Access Compliance Report

Public Rights-of-Way

(Pedestrian Signals)

Intersection ID: N/A	Main Street:	Cross Street: N/A	Location: N/A
ADA ID: E13B2BDA4086	Signal Type: One Push Button-APS	Overall Compliance: No	Severity Score: BTN 1: N/A BTN 2: N/A No BTN: N/A
Codes/Mitigation Info/Possible Solution		Field Measurements/Component Compliance

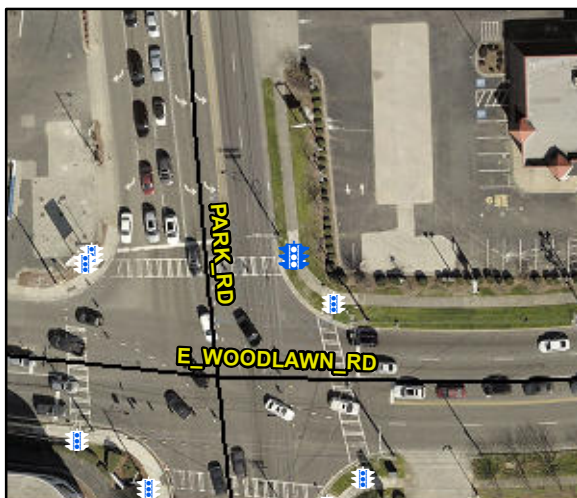
Possible Solutions: Remove & Replace
Replace APS Button With New APS Button.
Remove and Replace Clear Space.

PROW/ADA: R404.2, R406.2, R209.1, MUTCD 4e.10
